Re: Office of Emergency Management
2 Lafayette Street, Radio Room
Our Job No. 1854-08

The following is the **REQUEST FOR A PROPOSAL** to install an alarm system to monitor conditions in the radio room located at 2 Lafayette Street from the watch command room at The Office of Emergency Management at 7 World Trade Center:

NO.	BY	REVISION	DATE
OEM - RADIO ROOM 2 LAFAYETTE STREET 25TH FLOOR PART PLAN			
DATE: 12-29-98		SCALE: 1/4" = 1'-0"	
JOB NO: 12543		DRAWING NUMBER: SKM-1	
DRAWN: BT			
CHECKED: VL			
<i>Cosentini Associates</i> LLP CONSULTING ENGINEERS TWO PENNSYLVANIA PLAZA, NEW YORK, N.Y. 10121

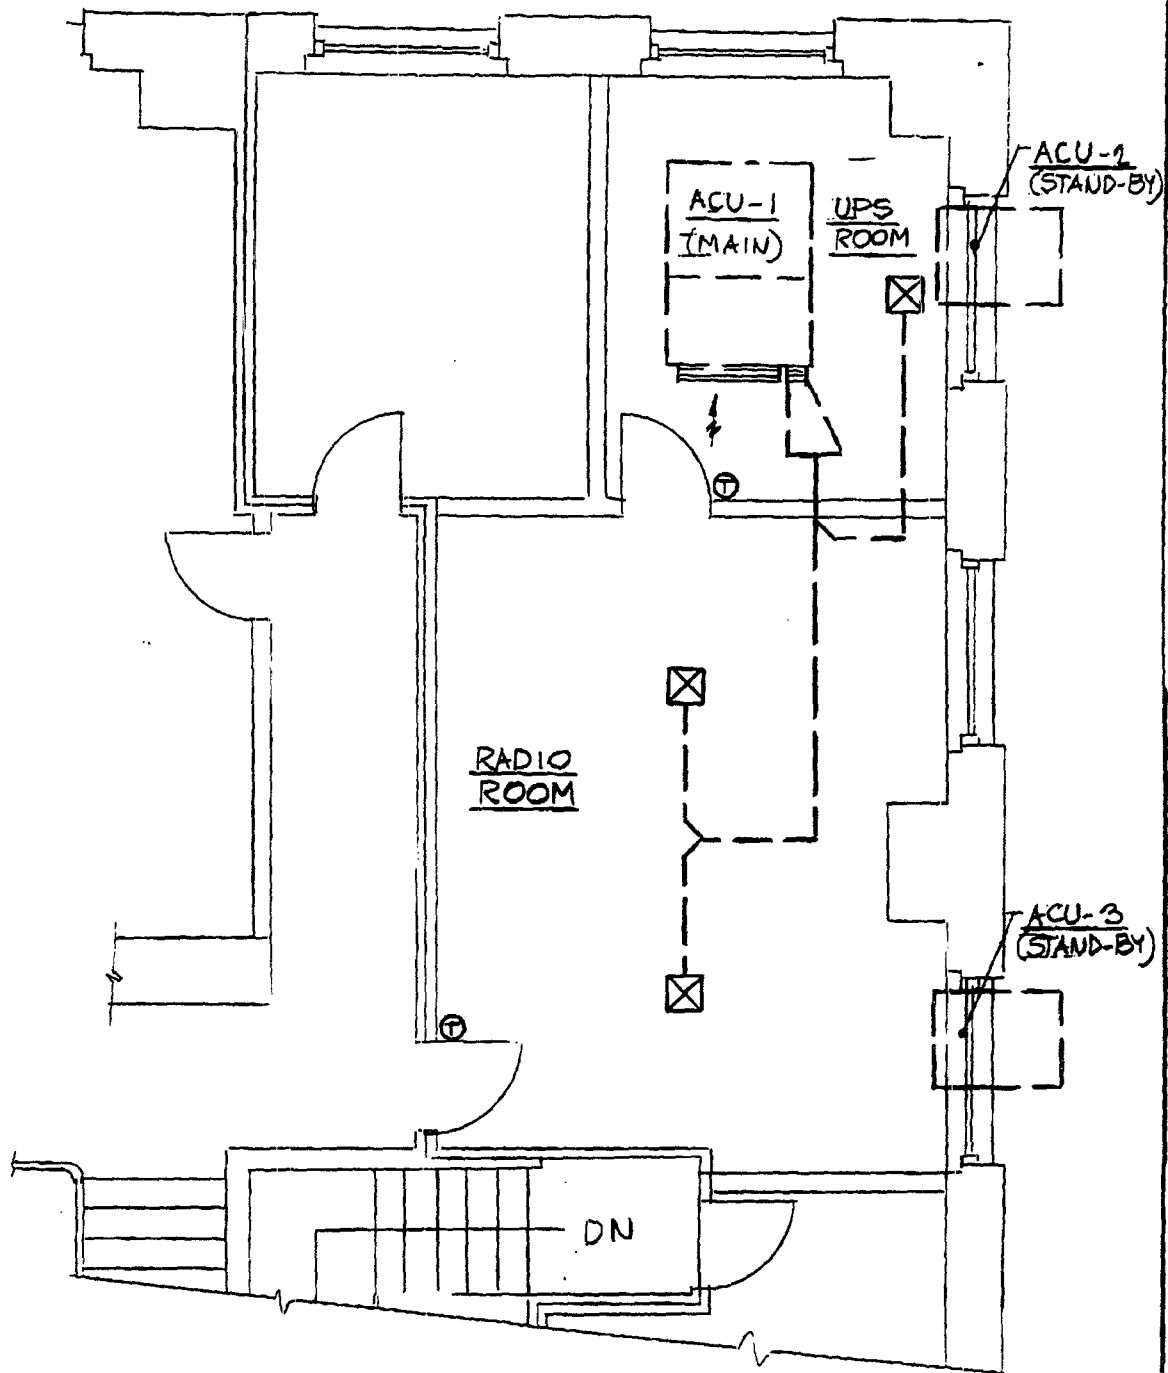
System shall be capable to monitor at 2 Lafayette Street and alarm at 7 World Trade Center the following point:

1. UPS room - high and low room temperature.
2. Radio room - high and low room temperature.
3. UPS - normal operation.
4. Automatic transfer switch - emergency position.
5. Main air conditioning unit - emergency shut down.
6. Stand by air conditioning unit serving UPS room in operation.

7. Stand-by air conditioning unit serving radio room in operation.

System shall consist of all required sensors, control and communication panels, network dialing module and compatible modem.

Provide air flow switch, dry contacts, relay etc., as required to achieve equipment monitoring functions.
